Harris-Shepherd Residence

From: The Columbia County Building & Zoning Department  
Plan Review  
135 NE Hernando Av.  
P.O. Box 1529  
Lake City Florida 32056-1529

Reference to a building permit application Number: **0905-21**

Applicant: Diane Shepherd Owner/Builder: Property Identification number:  
8-6S-17-096266-116  
On the date of May 22, 2009 application 0905-21 and plans were reviewed for  
compliance of the 2007 Florida building code/ Residential. The documents are  
plans submitted are for construction of a R3 single family dwelling.

## ELECTRICAL PLAN

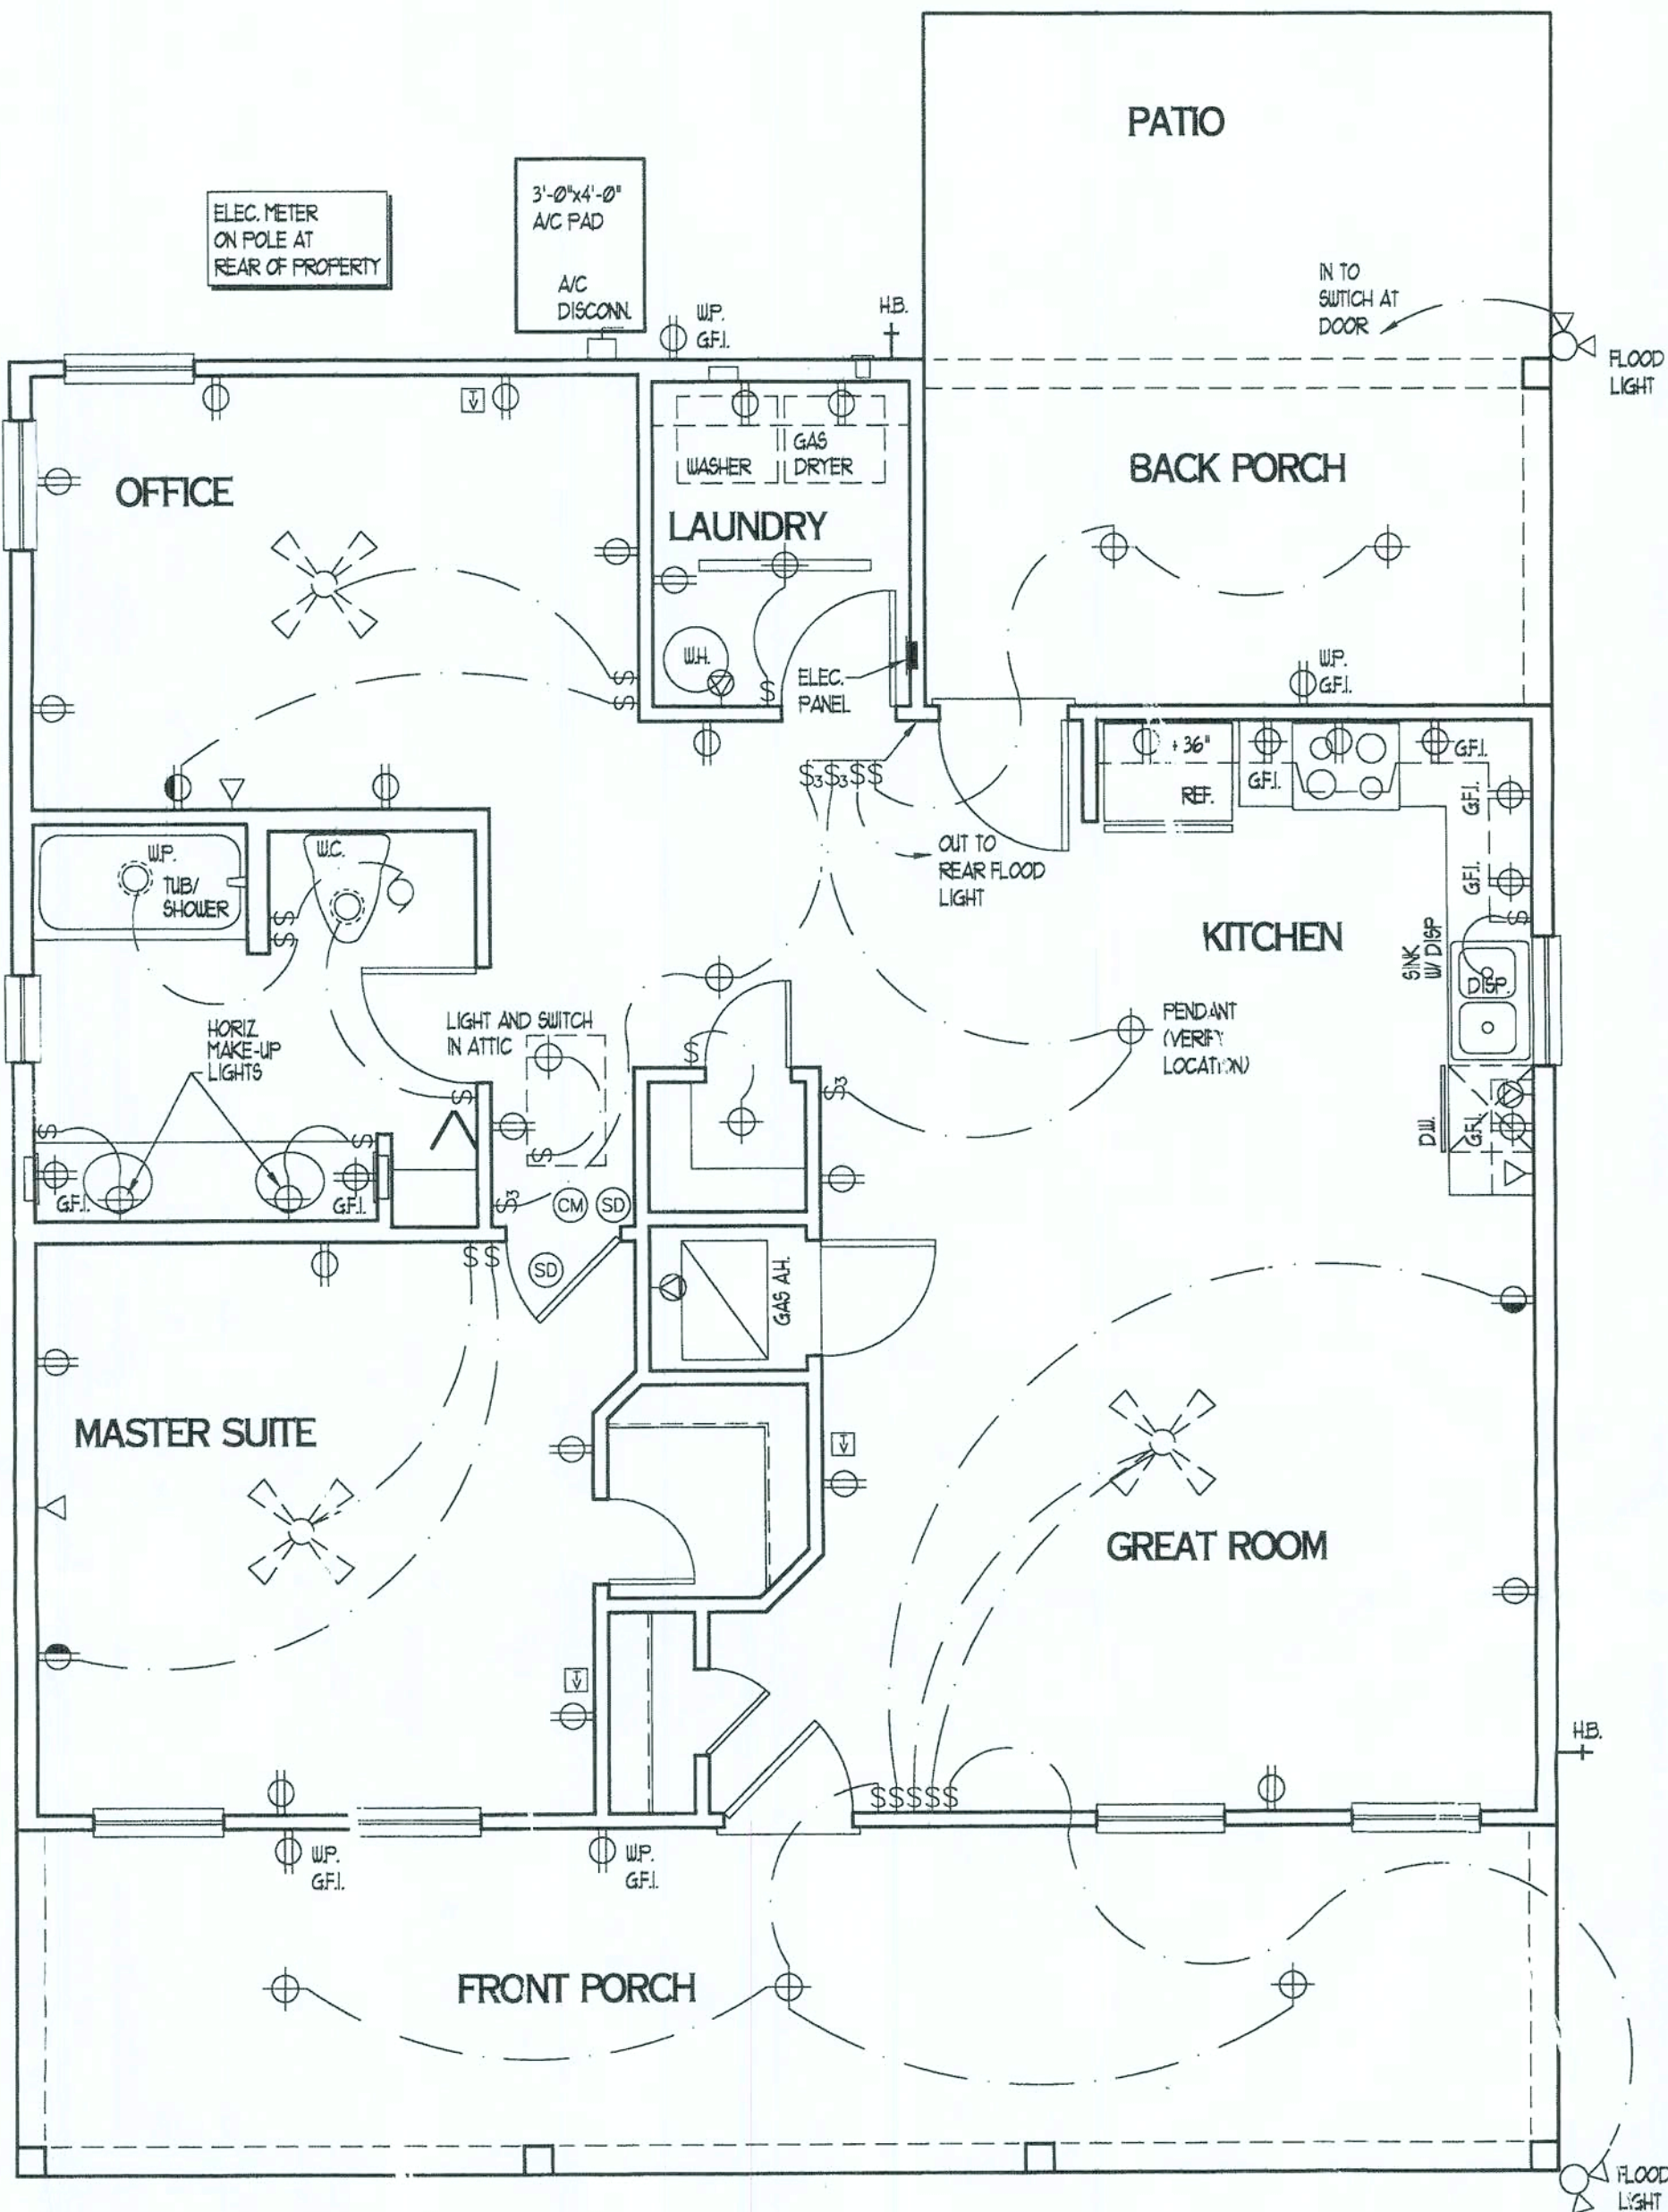
On the electrical plan all circuits within the bedroom shall be protected with an  
Arc-Fault Circuit breaker.

At the electrical service entrance point (utility author meter base) an overcurrent  
protection device shall be installed on the exterior of structure which will provide  
overcurrent protection for the total service amperage rating and a means of  
disconnecting electrical service from the serving utility company. Conductors  
used from the exterior disconnecting means to a panel or sub panel shall have  
four-wire conductors, of which one conductor shall be used as an equipment  
ground.
